Exhibit 1: Brooks Atkinson Theater

Exh. 1B Architectural Modifications to Brooks Atkinson Theater

1. BROOKS THEATER ORCHESTRA LEVEL ACCESSIBLE TOILET ROOM PLAN

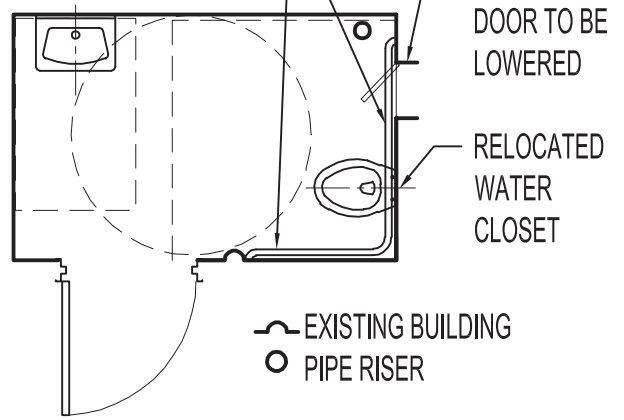
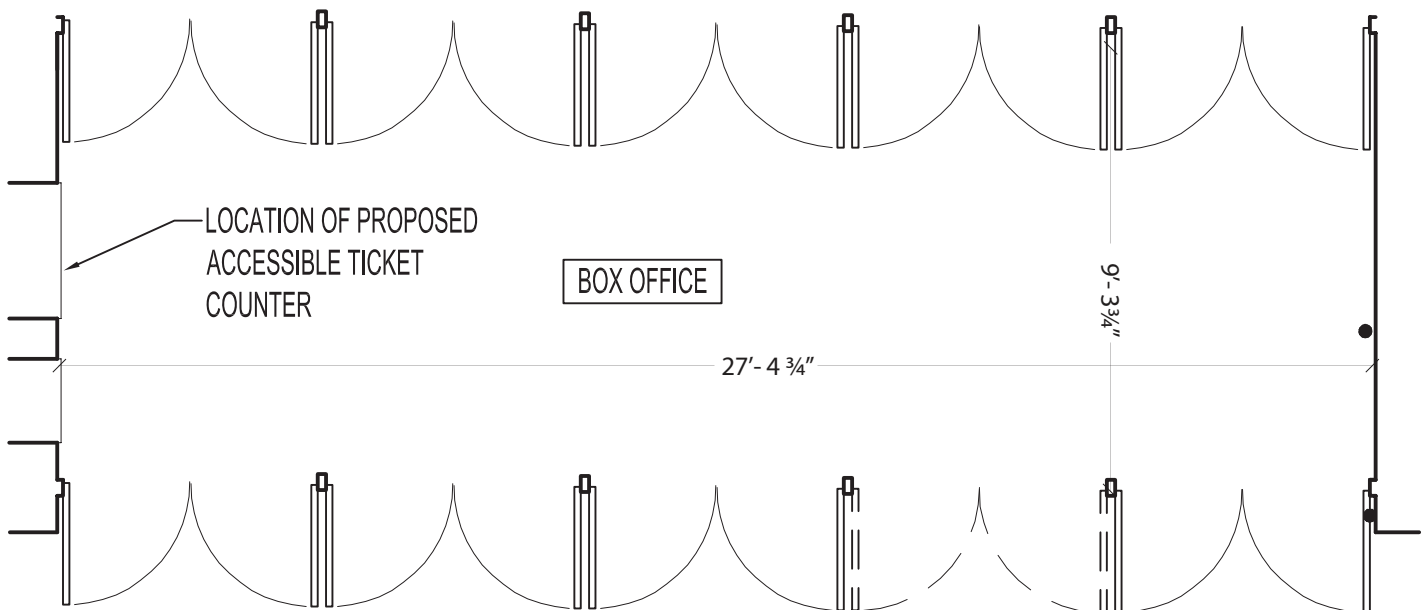
42	Orchestra Level (Accessible Toilet Room)	Toilet room is 61" deep from wall adjacent to water closet to lavatory wall. This leaves less than 30" clear between front edge of lavatory and side of water closet and far less than the 60" required in an alcove placement.	Toilet room is 61" deep from wall adjacent to water closet to lavatory wall. This leaves less than 30" clear between front edge of lavatory and side of water closet and far less than the 60" required in an alcove placement.	4.2.4 4.19.3	Defendant will provide compliant clearance.
43	Orchestra Level (Accessible Toilet Room)	The rear grab bar is 24" long, located 8" from the side wall.	Rear grab bar < 36" long and is not within 6" of side wall.	4.1.3(11) 4.22.4 4.17.6 4.26 Fig.30	Defendant will provide compliant rear grab bar.
44	Orchestra Level (Accessible Toilet Room)	The side grab bar is 24" long, located 8" from the rear wall extending to 32" from rear wall instead of 54" minimum. Door and vertical element at side wall complicate solution.	Side grab bar is less than 42" long.	4.1.3(11) 4.22.4 4.17.6 4.26 Fig. 30	Defendant will provide compliant side grab bar, and extend and coordinate grab bar with existing building pipe riser.

45	Orchestra Level (Accessible Toilet Room)	The water closet is 22" from centerline to side wall.	The centerline of the water closet is more than 18" from the side wall.	4.1.3(11) 4.22.4 4.17.2 4.16 Fig.30	Defendant will relocate water closet at compliant distance from the side wall.
46	Orchestra Level (Accessible Toilet Room)	Missing signage.	There is no raised lettering and Braille room identification sign provided at this unisex single user toilet room	4.1.3(16)(a) 4.30.1 4.30.4 4.30.5 4.30.6	Defendant will provide compliant signage.

Line #	Location Description	Existing Condition	Barrier Description	1991 Standards Reference	Architectural Modification
47	Orchestra Level (Accessible Toilet Room)	The toilet paper dispenser is located 3" above the side grab bar which blocks access. The current Standards show 18" clear minimum in Figure 39(d). Under New ADAAG, where the dimension is most clearly specified, at least 12" must be maintained.	Toilet paper dispenser obstructs grab bar.	4.26.2 Fig. 39(d) 2010 ADAAG 604.7	Defendant will install compliant toilet dispenser.
48	Orchestra Level (Accessible Toilet Room)	The lavatory rim height is 37" AFF, knee space is 24" AFF.	Wall-mounted lavatory has rim above 34" AFF with less than 29" minimum AFF knee clearance at front and 27" minimum AFF at 8" deep.	4.1.3(11) 4.22.6 4.19.2, Fig. 31	Defendant will provide compliant lavatory.
49	Building	There is no directional signage to the accessible toilet room.	No directional signage to nearest accessible toilet room at inaccessible toilet rooms.	4.1.2(7)(d) 4.1.6(3)(e)(iii)	Defendant will provide compliant signage.

1. BROOKS THEATER BOX OFFICE/ENTRANCE PLAN

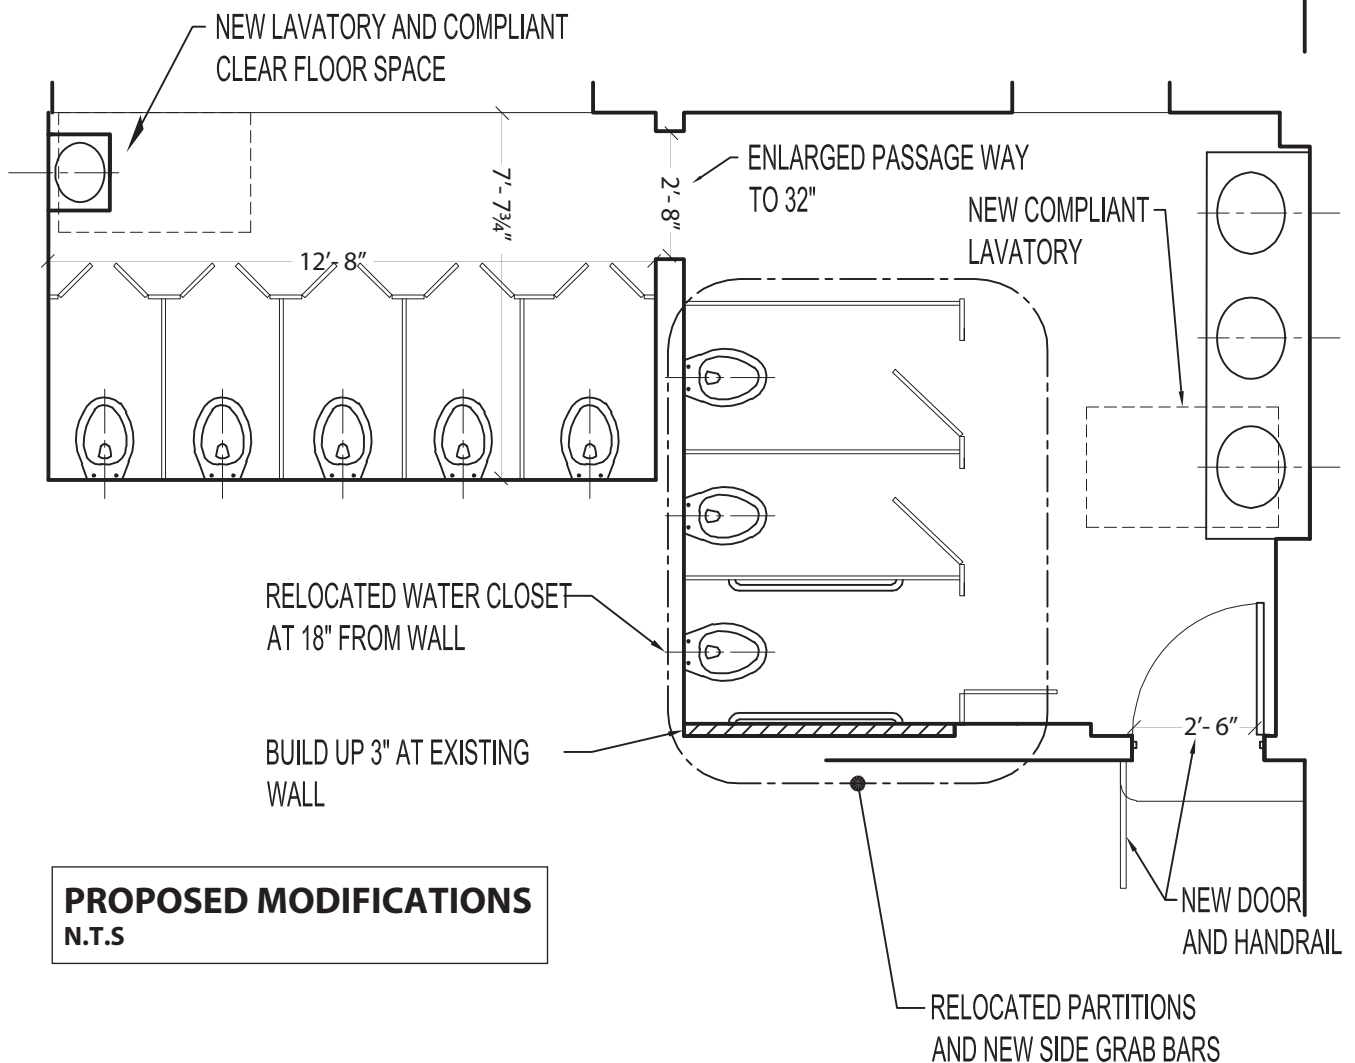
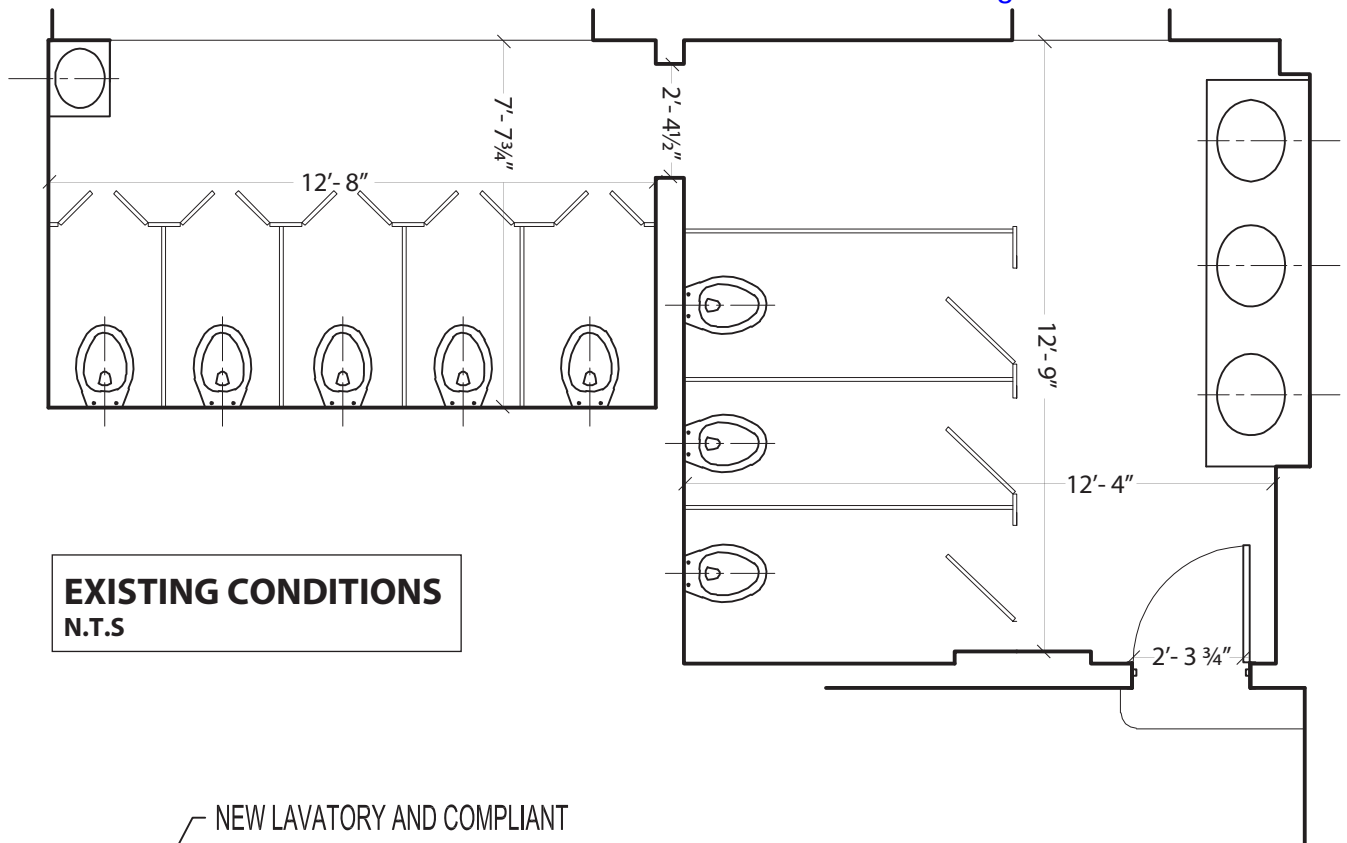
Line #	Location Description	Existing Condition	Barrier Description	1991 Standards Reference	Architectural Modification
33	Women's Toilet Room Adjoining Toilet Room (Balcony Level)	The paper towel dispenser is 55" AFF. Although some paper towels are also stacked on the window sill at 35" AFF, that does not provide equivalent facilitation.	Towel dispenser is mounted outside of reach range.	4.1.3(11) 4.22.7 4.27.3	Defendant will provide compliant mounting height of dispenser.
34	Box Office	There are 5 pairs of 31" wide doors that provide only 28" clear width at the main entry.	Clearance width less than 32" at doorway (or active leaf of double door).	4.13.5 4.1.3(7) Fig. 24	Automatic doors have been provided during course of investigation.
35	Box Office	Exit door #4 between theatre & box office has no center mullion and, therefore provides 54" clear width when both doors are open (still insufficient width with only one door open). The panic hardware is 33" AFF and the clear width between the panic bars is 44" with both doors open.	Clearance width less than 32" at doorway (or active leaf of double door).	4.13.5 4.1.3(7) Fig. 24	The entrance to, and the exit from, the theater is through the alleyway east of the Box office, where theater personnel are at all times located to assist the public.

36	Box Office	There is no folding armrest signage.	No signage is provided at the ticket office notifying patrons of the availability of seating with folding or removable armrests.	4.1.3(19)(a)	Defendant will provide compliant signage.
37	Box Office		No signage is provided at the ticket office notifying patrons of the availability of an assistive listening system.	4.1.3(19)(b) 4.33 4.30.7, Fig. 43(d)	Defendant has provided ALS, and will continue to do so. Defendant shall post signage advising patrons of the availability of ALS.
38	Box Office	The ticket sales counters are 41" AFF and 44" AFF.	Sales, service, or information counter is higher than 36" AFF at cash register(s) for sales or distribution of goods or services to the public.	7.2(2) 4.3	Defendant will provide compliant ticket counter.

1. BROOKS ATKINSON THEATER
BALCONY LEVEL WOMEN TOILET ROOM PLAN

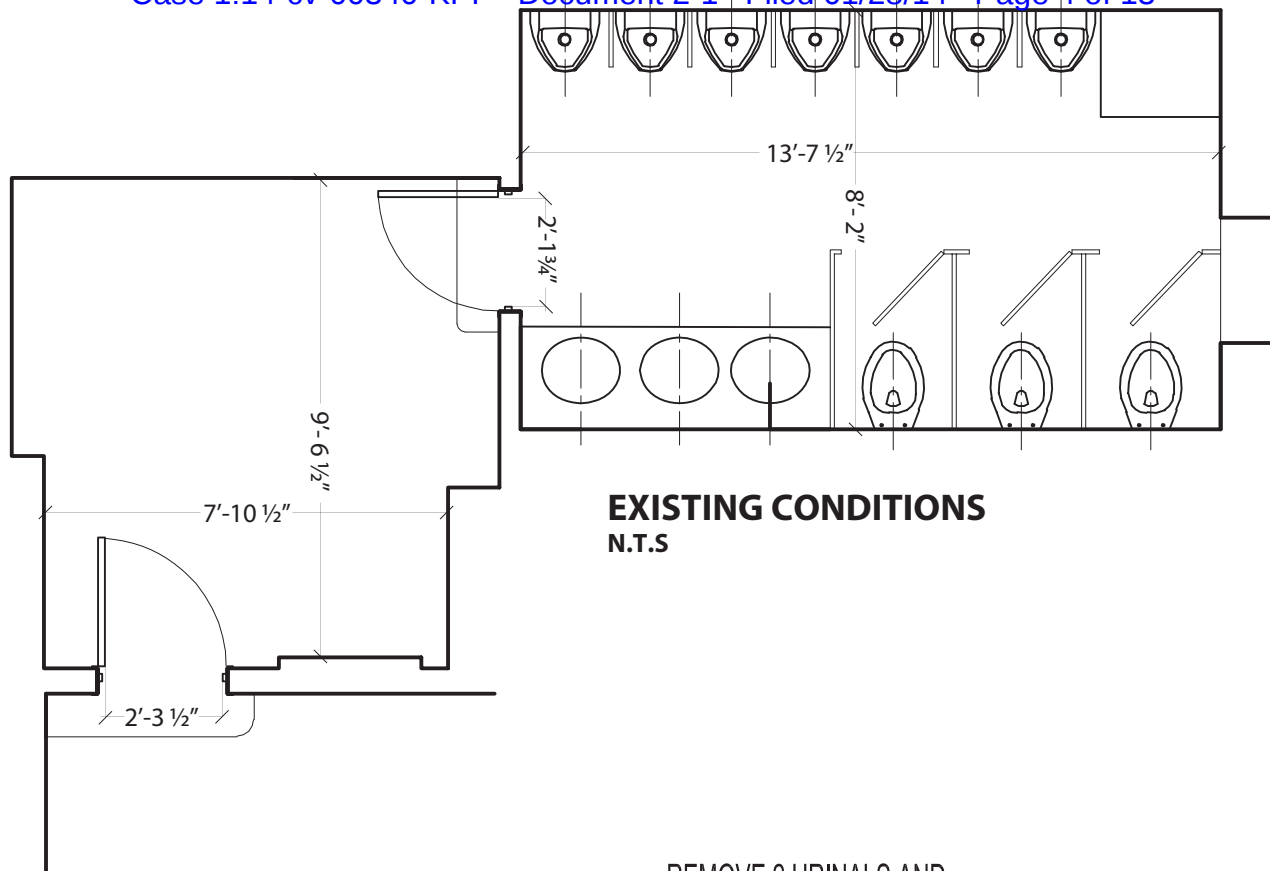
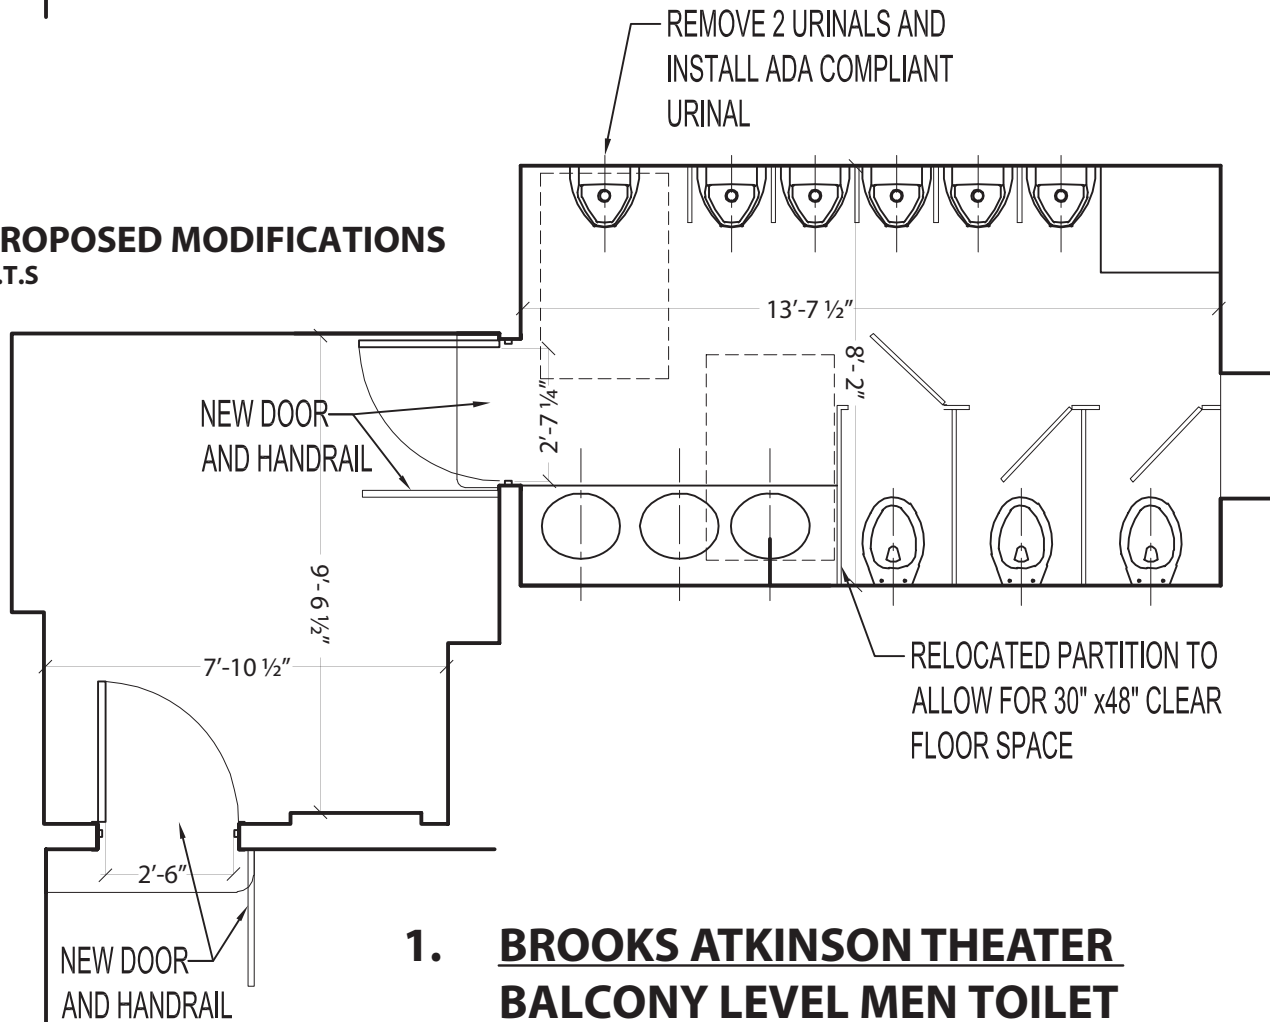
21	Women's Toilet Room (Balcony Level)	The mirror is mounted at 48" AFF to the bottom of the reflecting surface.	Bottom of mirror reflecting surface is greater than 40" above finish floor.	4.1.3(11) 4.22.6 4.19.6	Defendant will provide compliant mirror.
22	Women's Toilet Room and Adjoining Toilet Room (Balcony Level)	The mirror is mounted at 45" AFF to the bottom of the reflecting surface in the adjoining toilet room.	Bottom of mirror reflecting surface is greater than 40" above finish floor.	4.1.3(11) 4.22.6 4.19.6	Defendant will provide compliant height of mirror.
23	Women's Toilet Room and Adjoining Toilet Room (Balcony Level)	Adjacent connected toilet room is accessed through a 28" framed opening.	Clearance width is less than 32" at cased opening.	4.13.5 Fig. 24	Defendant will provide compliant clearance width.
24	Women's Toilet Room (Balcony Level)	Toilet room is up 2 steps without compliant handrails through a 29" clear width door.	Toilet Room is not on an accessible route and entrance door has less than 32" of clear width. Steps serving level not served by an accessible route do not have compliant handrails.	4.13.5 4.1.3(7) Fig. 24	Defendant will provide compliant door as far as readily achievable, at 30", with handrails.

25	Women's Toilet Room (Balcony Level)	Signage is mirrored.	Existing signage does not have nonglare finish.	4.1.3(16)(a) 4.30.5	Defendant will provide compliant signage.
26	Women's Toilet Room (Balcony Level)	Faucets require grasping, twisting, and 7 pounds of force to operate.	Faucet controls require more than 5 pounds of force and grasping, pinching, or twisting to operate.	4.1.3(11) 4.22.6 4.19.5 4.27.4	Defendant will provide compliant faucets.

Line #	Location Description	Existing Condition	Barrier Description	1991 Standards Reference	Architectural Modification
27	Women's Toilet Room and Adjoining Toilet Room (Balcony Level)	There are 3 stalls at 48" deep, none of which are accessible or have grab bars. There is an adjoining toilet room which has 5 additional stalls, none of which are accessible or have grab bars. These stalls are 48" deep. One of these stalls is 26" wide, three are 29" wide, and one is 33" wide.	There is no accessible toilet stall.	4.1.3(11) 4.22	Defendant will provide an accessible alternate stall.
28	Women's Toilet Room (Balcony Level)	The lavatories have no knee space, countertop rim is 36" AFF.	The counter mounted lavatory rim is above 34" AFF and has no knee clearance (29" minimum AFF at front, 27" minimum AFF at 8" deep).	4.1.3(11) 4.22.6 4.19.2, Fig. 31	Defendant will provide compliant lavatory.
29	Women's Toilet Room (Balcony Level)	Toilet room door requires 21 pounds of force at point where door is binding in the frame and 3 pounds for remaining travel to open position.	The door requires more than 5 pounds of force to open.	4.1.3(7)(c) 4.13.10	Defendant will provide compliant door.

30	Women's Toilet Room Adjoining Toilet Room (Balcony Level)	Lavatories in the adjoining toilet room provide 27" AFF knee space at front edge and 24" AFF at 8" back with the rim at 31" AFF.	The wall hung lavatories have less than the required knee clearance (29" minimum AFF at front, 27" minimum AFF at 8" deep).	4.1.3(11) 4.22.6 4.19.2, Fig. 31	Defendant will provide compliant lavatory.
31	Women's Toilet Room (Balcony Level)		There is no raised lettering and Braille room identification sign provided at this gender specific multi-user toilet room.	4.1.3(16)(a) 4.30.1 4.30.4 4.30.5 4.30.6	Defendant will provide compliant signage.
32	Women's Toilet Room (Balcony Level)	The paper towel dispenser is 49" AFF above a 16" deep round waste receptacle.	Towel dispenser is mounted outside of reach range.	4.1.3(11) 4.22.7 4.27.3	Defendant will provide compliant mounting height of dispenser.

Exhibit 1C: Seating

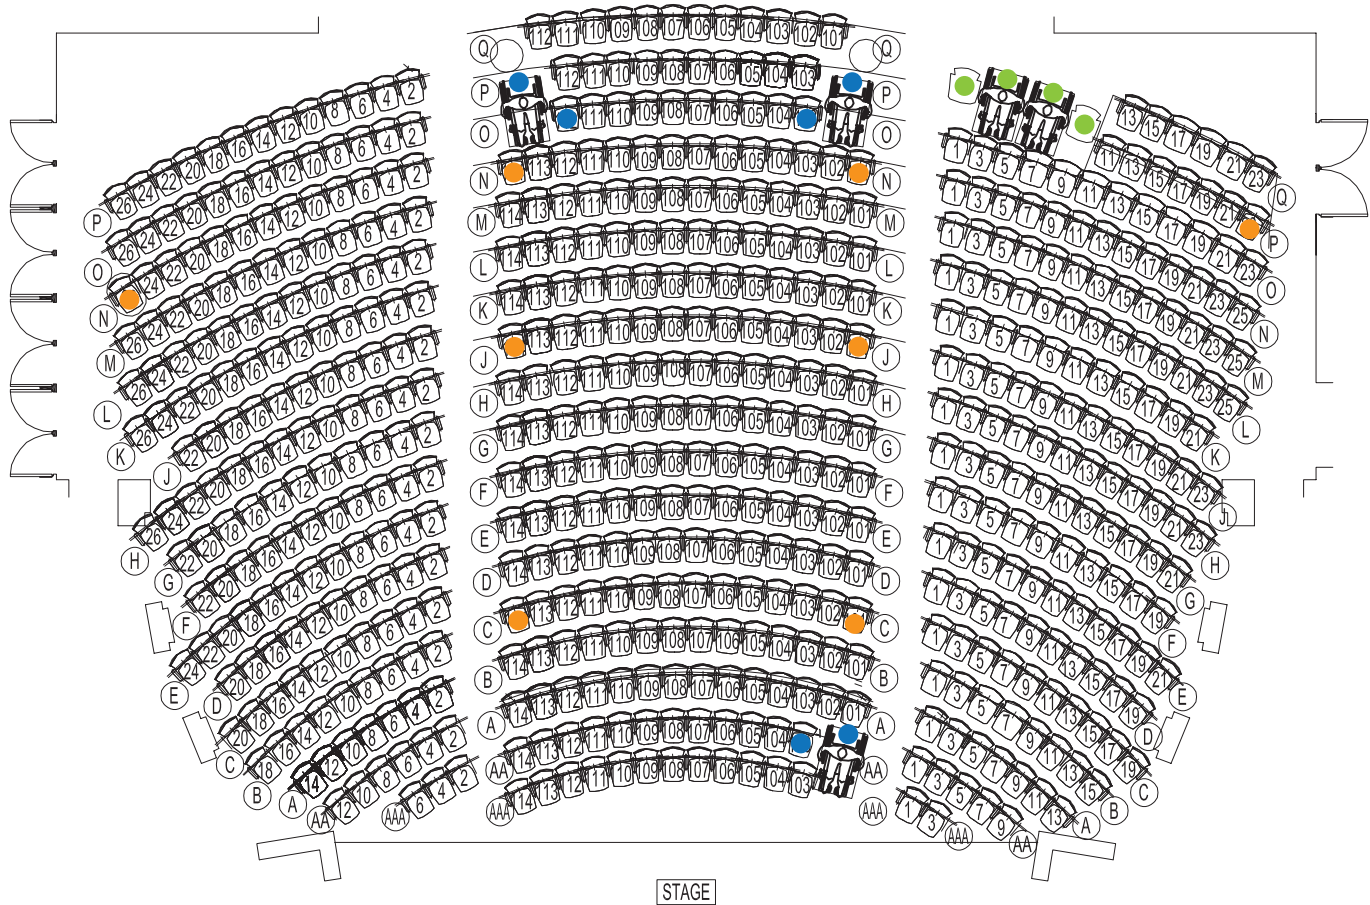
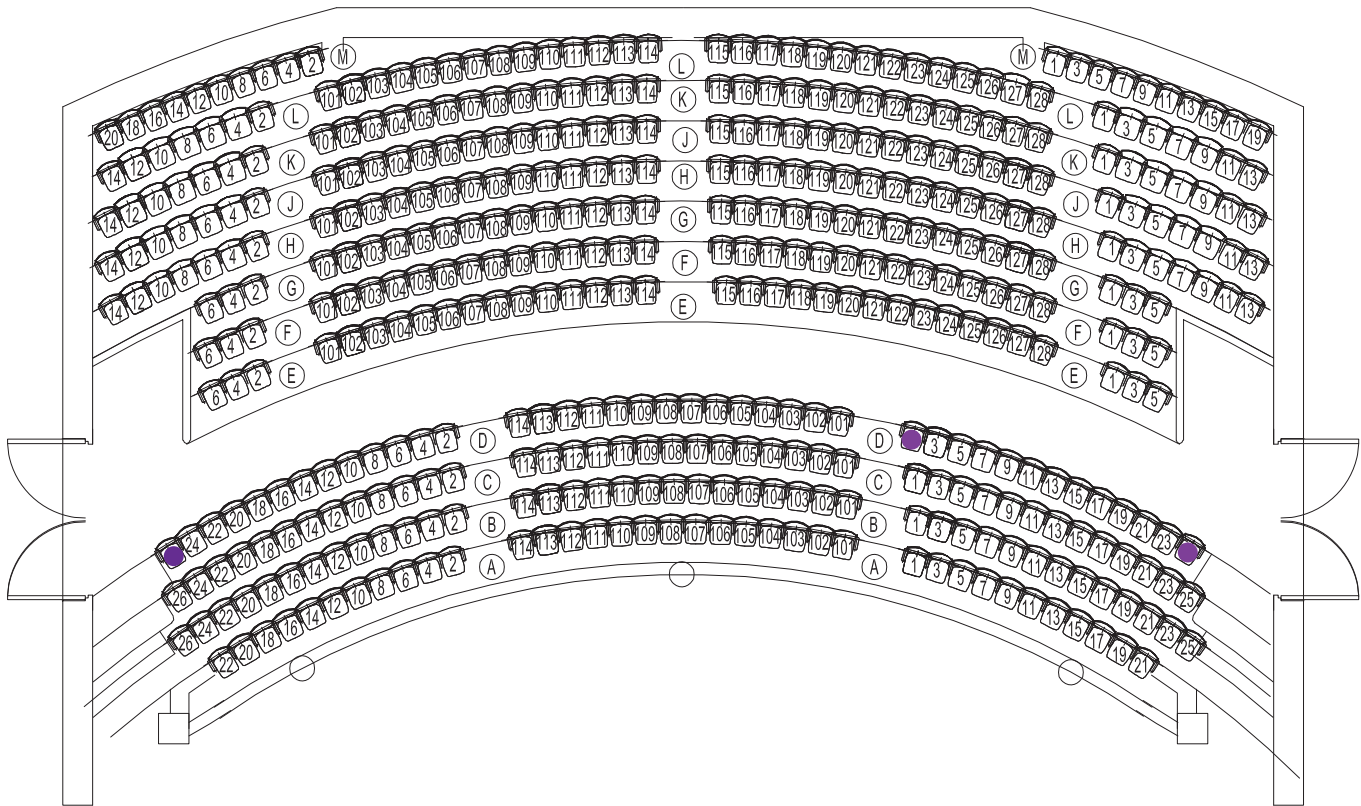
1. Nederlander shall maintain the two existing wheelchair and companion seating locations on the orchestra level, at P1/P3, and P5/P7/P9, which include companion seating locations.
2. Nederlander shall remove the black metal railings surrounding the existing wheelchair seating locations at P1/P3/P5/P7 on the Orchestra level.
3. Nederlander shall add three new wheelchair seating locations at Orchestra AAA101/AAA102/AA101/AA102; at O101/O102/P101/P102; and at O113/O114/P113/P114; with AA103, O103, and O112 being companion seating locations.

4. Nederlander shall maintain the eight existing aisle transfer seats on the Orchestra level at C101, C114, J101, J114, N101, N114, N26, and P23.
5. Nederlander shall add three new aisle transfer seating locations on the Mezzanine level, at D1, D25 and D26.
